WTC DRAWING
BOOK 19
AB-1–K-1055

SKILLING, HELLE, CHRISTIANSEN, ROBERTSON — Structural & Civil Engineers

PROJECT: THE WORLD TRADE CENTER | TITLE: DRAWING BOOK 19 - REVISIONS AFTER FABRICATION | DATE: 5/18/73

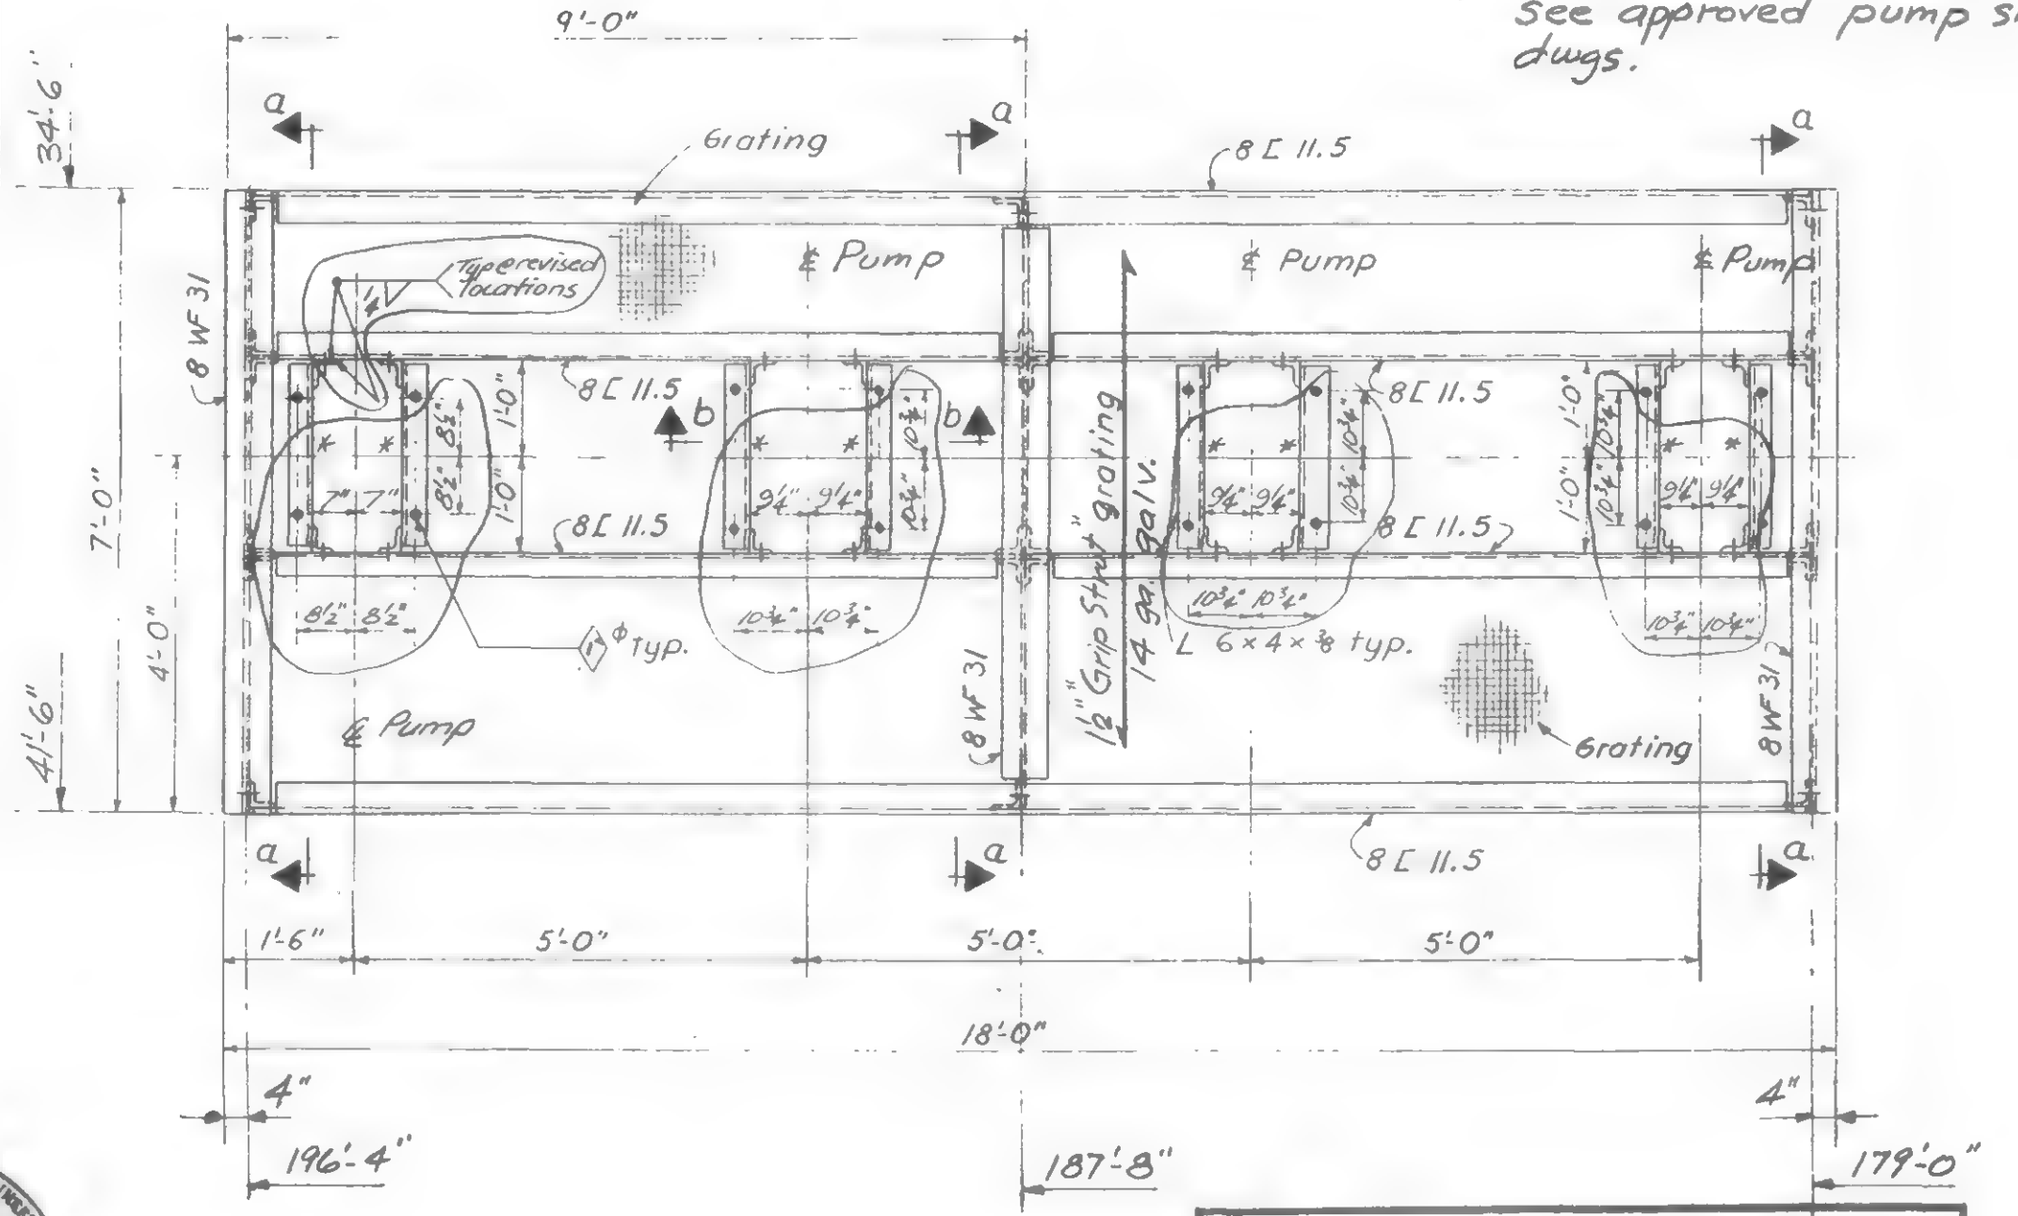
(+) Provide new 6×4×⅜ L and end clips. Connect to support Cs by field welds as shown.

(○) Revised pump bolt locations.

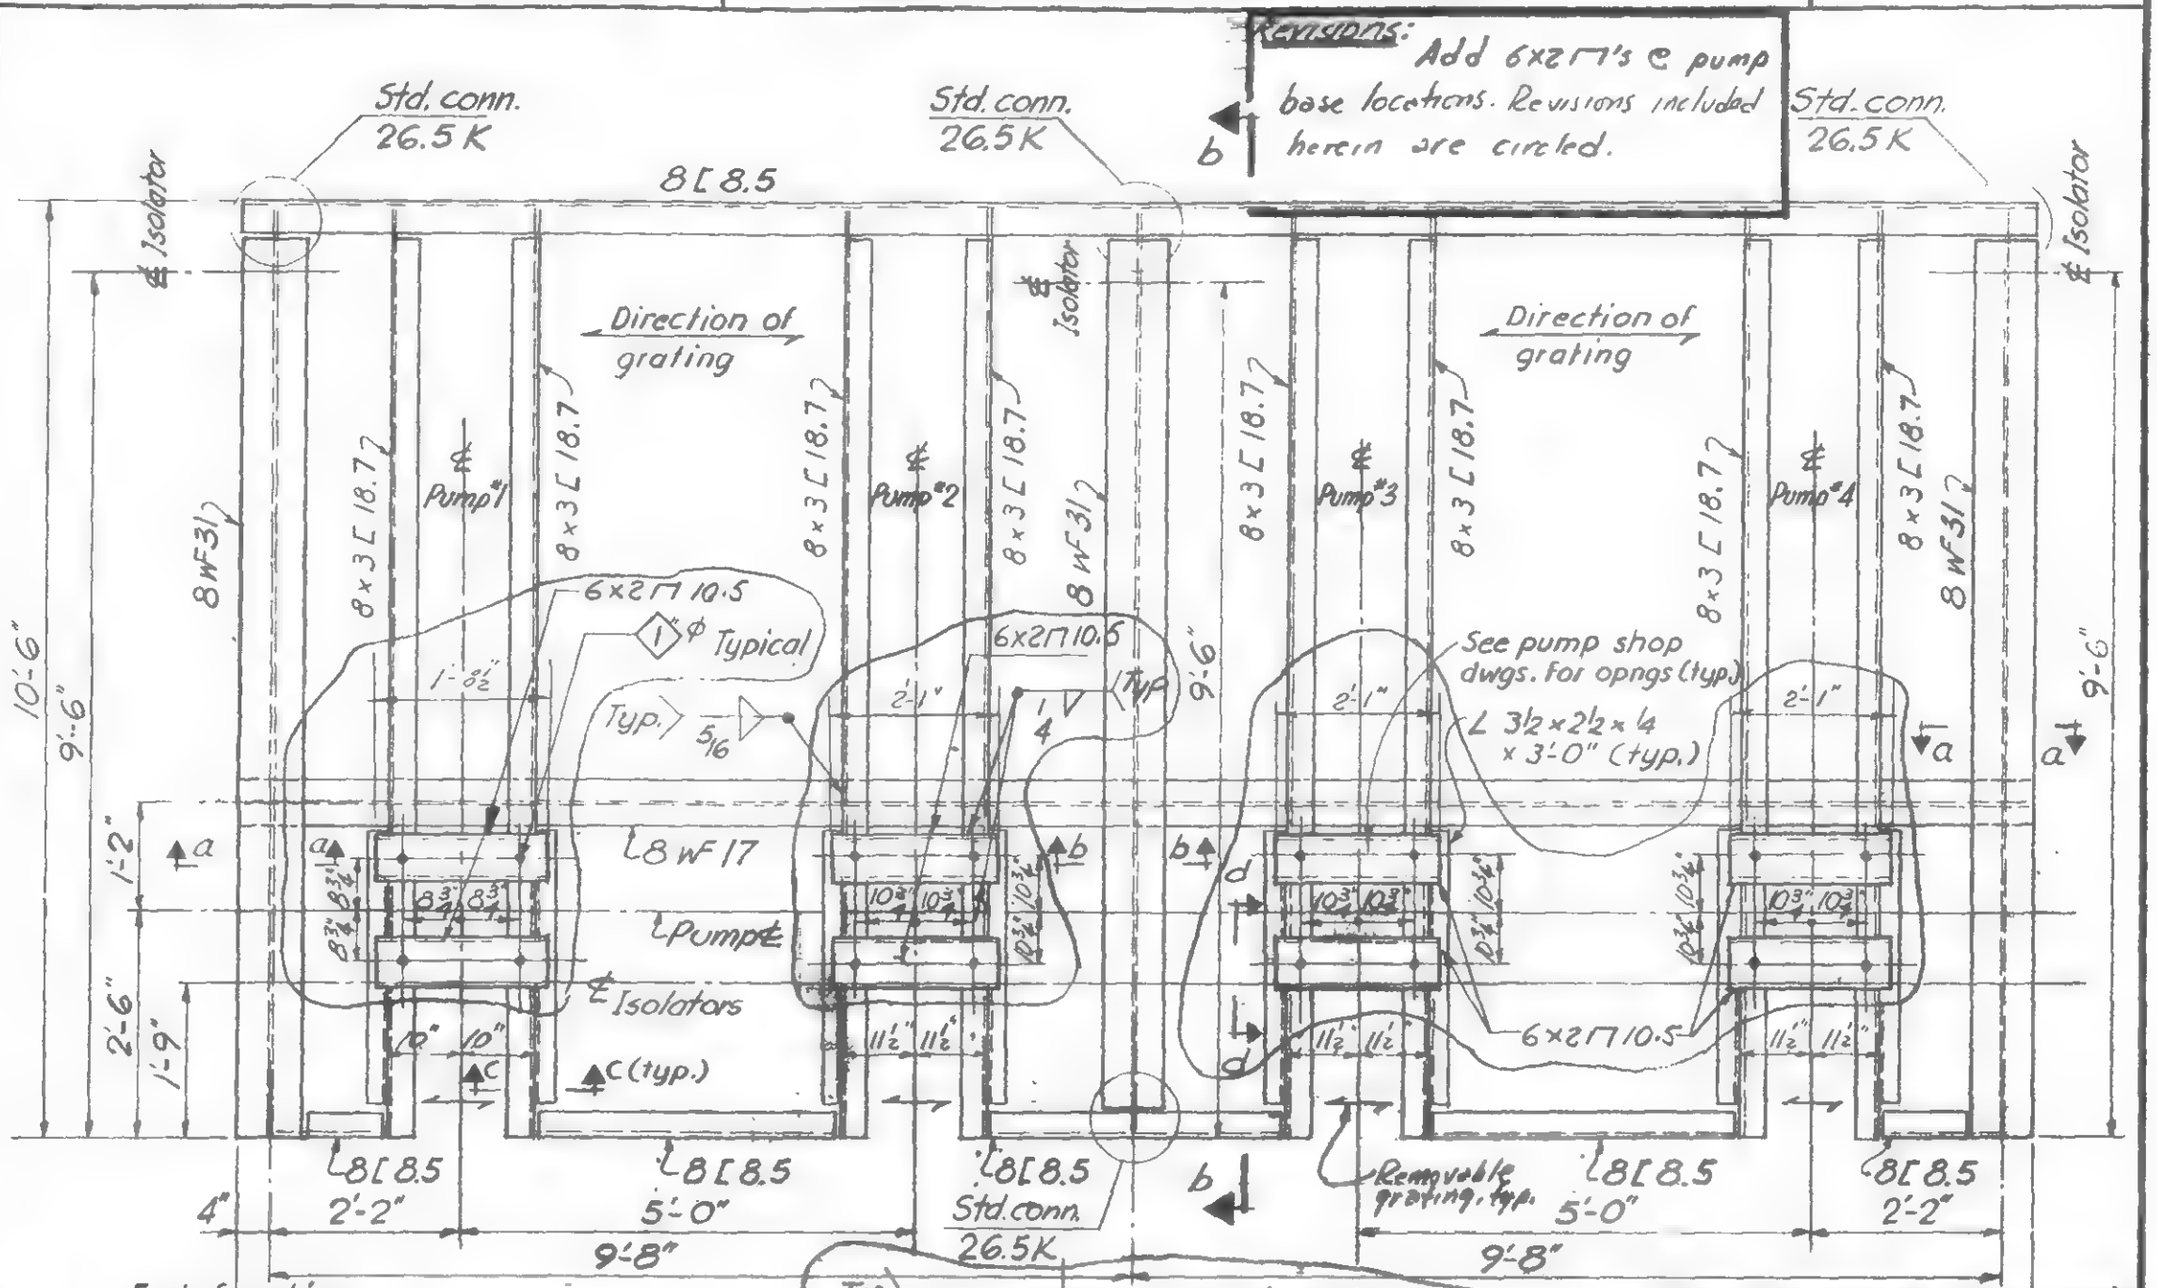
Revisions: Add 6x2⊓'s @ pump base locations. Revisions included herein are circled.

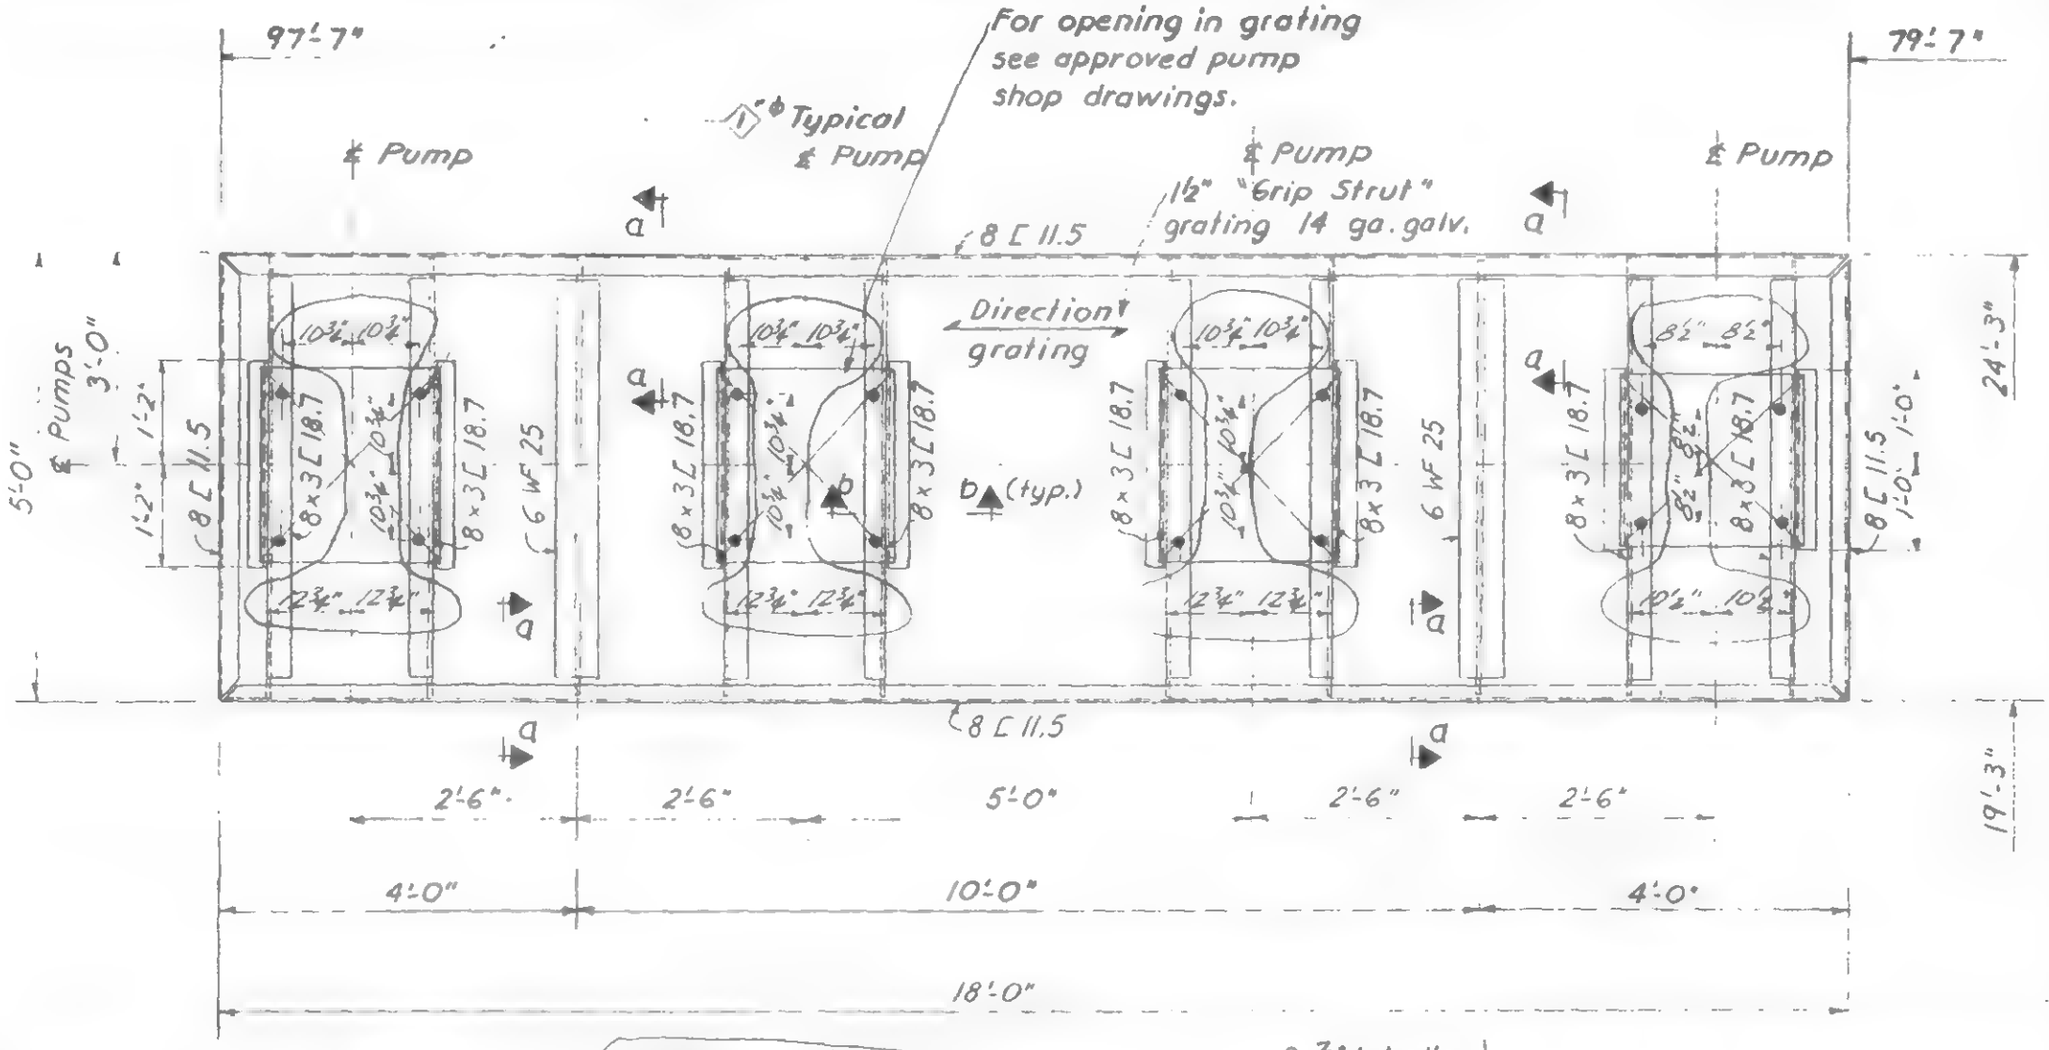
Revision work:
1. Revised pump bolt locations. Connect relocated members by field welding as shown.

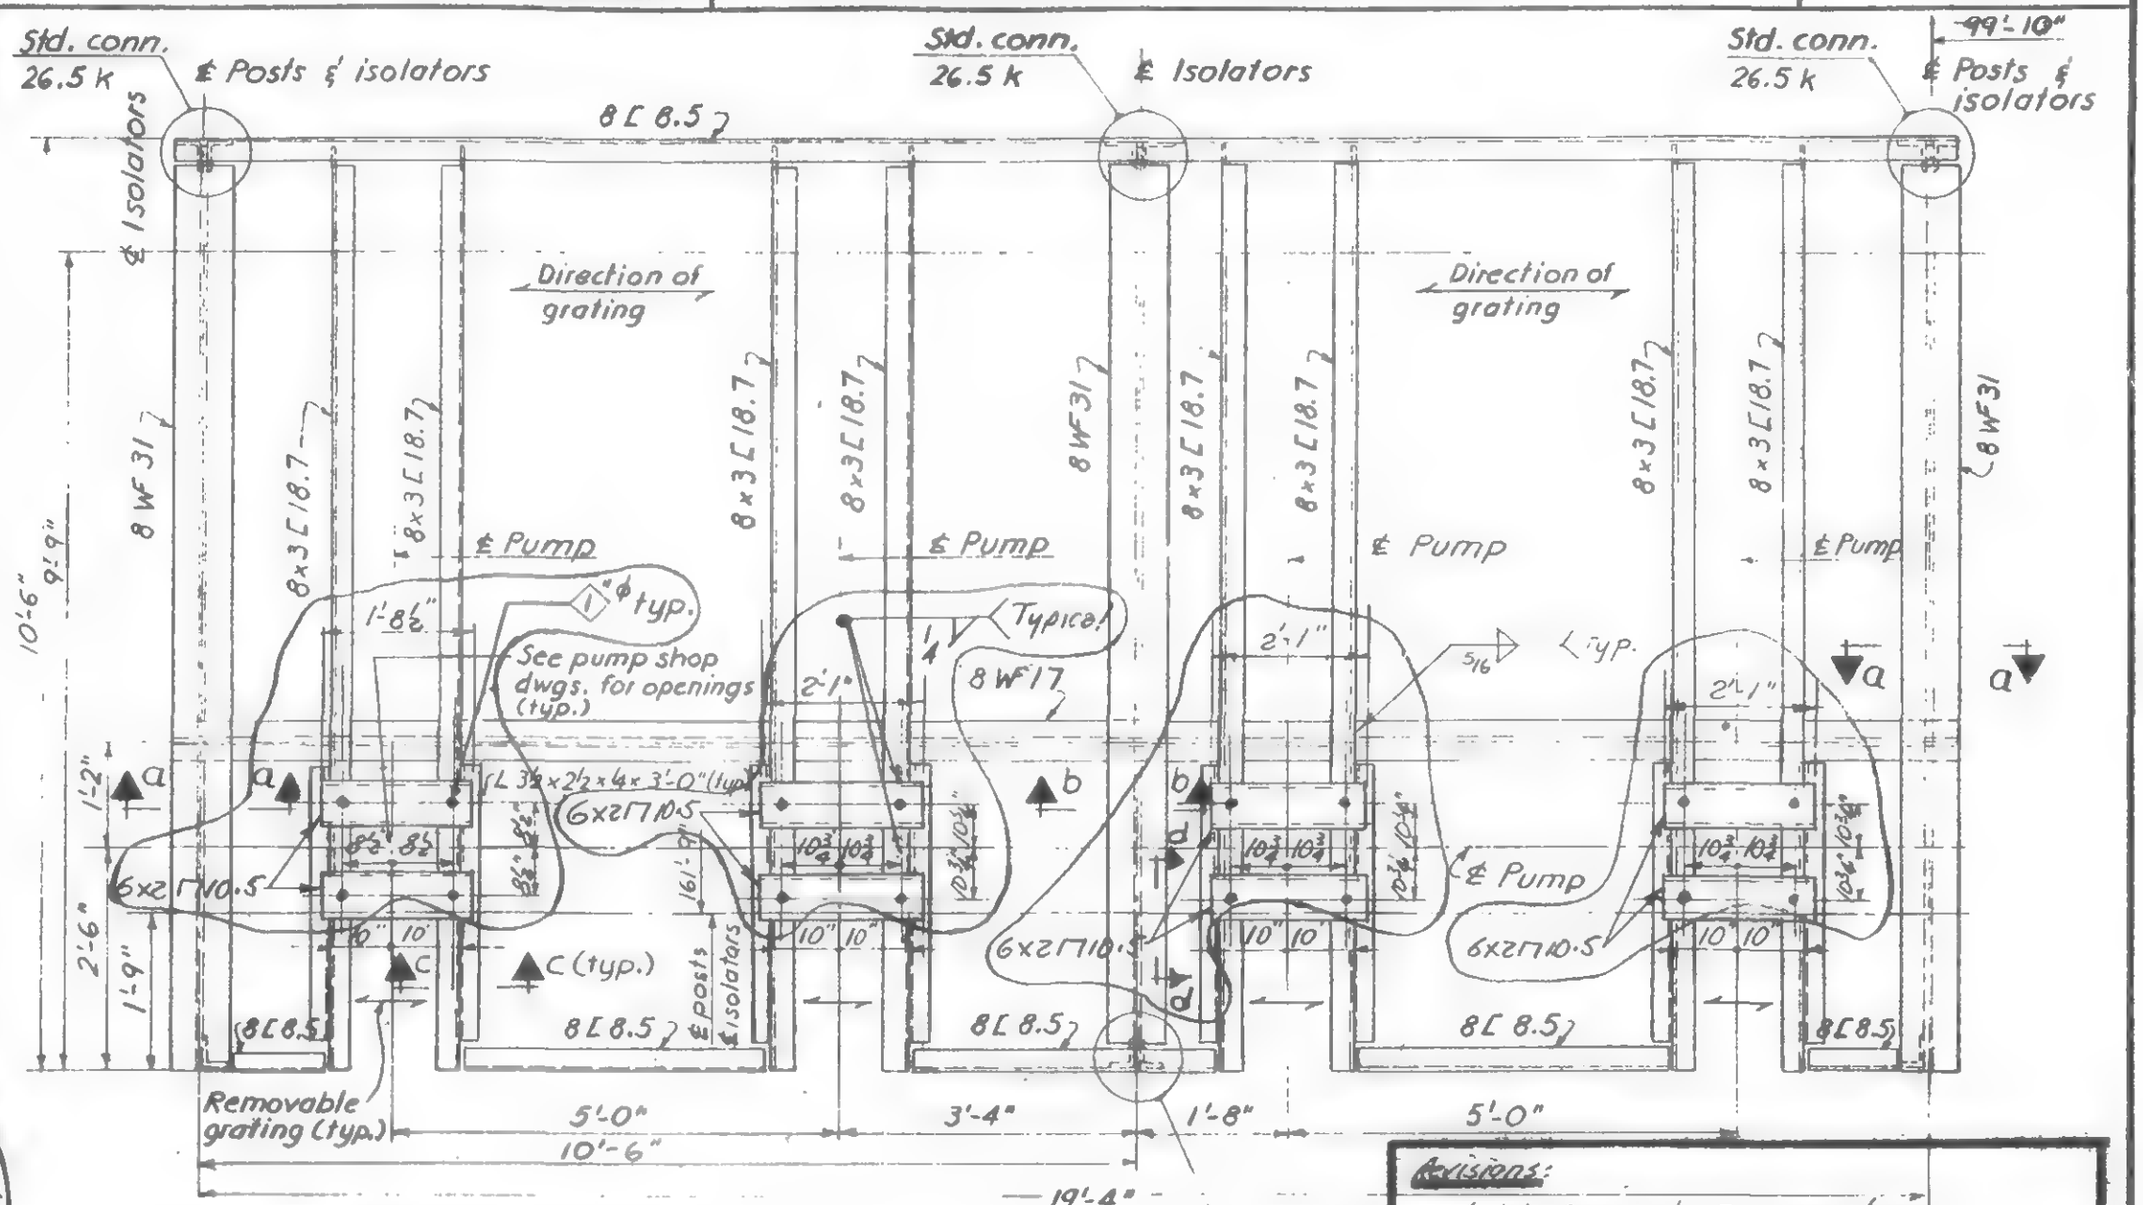
Revisions:
Add 6x2 C's @ pump base locations. Revisions included herein are circled
